SUBJECT: AMENDMENT NO. 44 TO FACILITY OPERATING LICENSE NO. NPF-30
(TAC NO. 69875)

The Commission has issued the enclosed Amendment No.44 to Facility Operating License No. NPF-30 for the Callaway Plant, Unit 1. This amendment revises the Technical Specifications (TS) in response to your application dated October 25, 1988.

CALLAWAY PLANT, UNIT 1

ATTACHMENT TO LICENSE AMENDMENT NO. 44

FIGURE 3.2-1

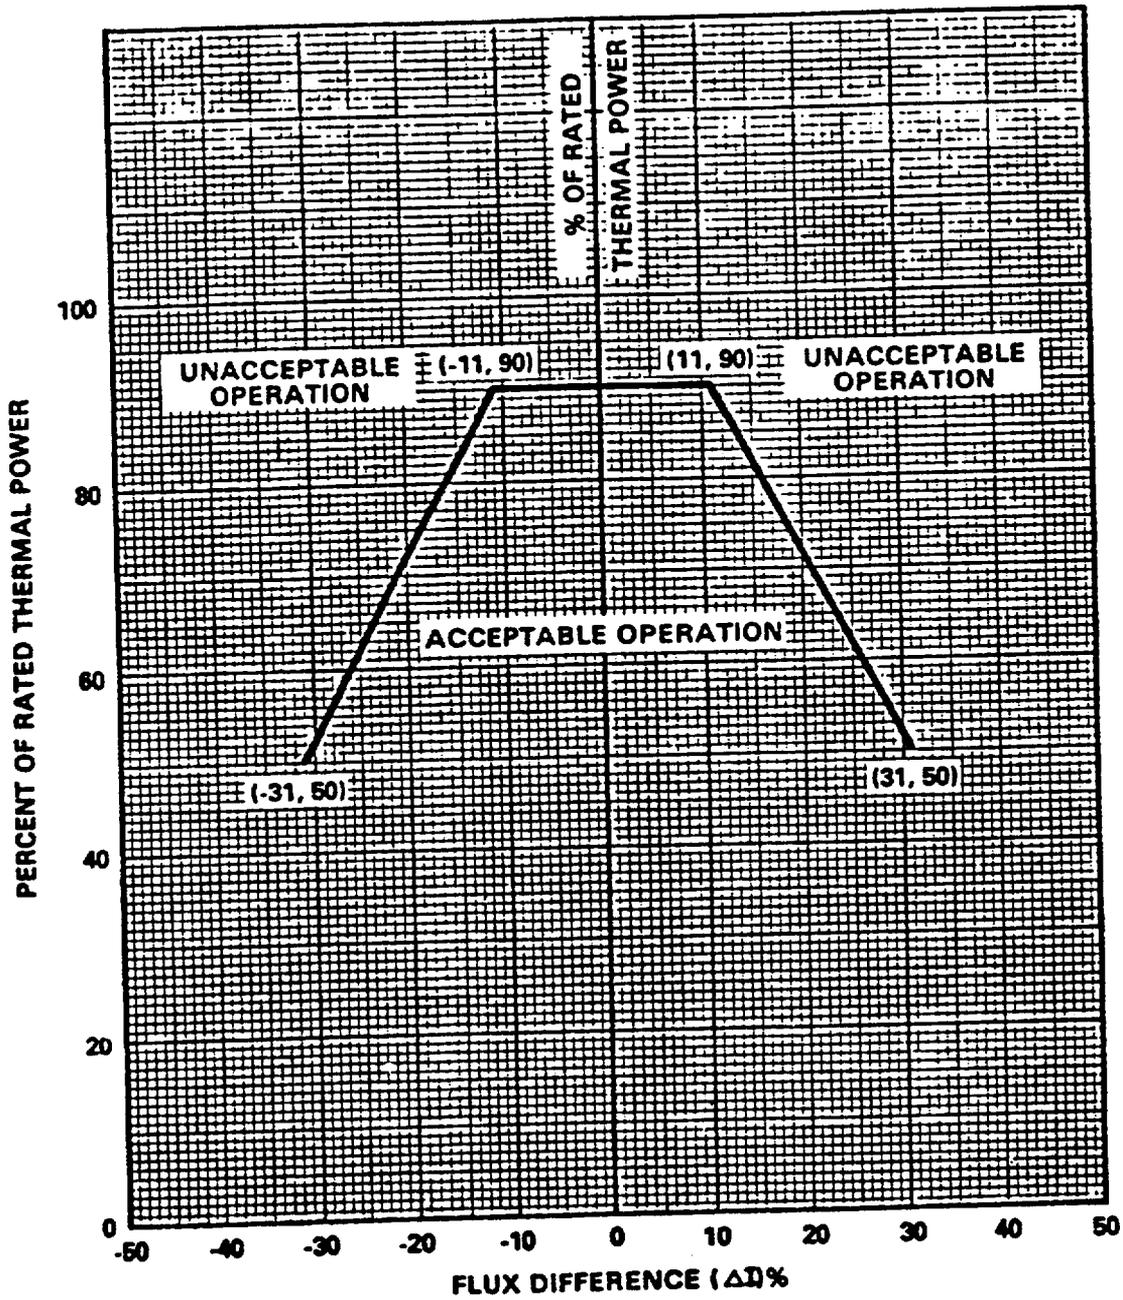
TS 3.2.1, TS 3.2.2, TS Fig 3.2.2, TS 4.2.2, TS 4.2.2.2, TS 4.2.2.3 and TS 4.2.2.4 are revised to include the increased heat flux hot channel factor, Fq.

3.2.1 The indicated AXIAL FLUX DIFFERENCE (AFD) shall be maintained within the following target band (flux difference units) about the target flux difference:

- a. +3%, -12% for Normal Operation
- b. +3% for RESTRICTED AFD OPERATION

The indicated AFD may deviate outside the applicable required target band at greater than or equal to 50% but less than 0.9 APLND** or 90% of RATED THERMAL POWER, whichever is less, provided the indicated AFD is within the Acceptable Operation Limits of Figure 3.2-1 and the cumulative penalty deviation times does not exceed 1 hour during the previous 24 hours.
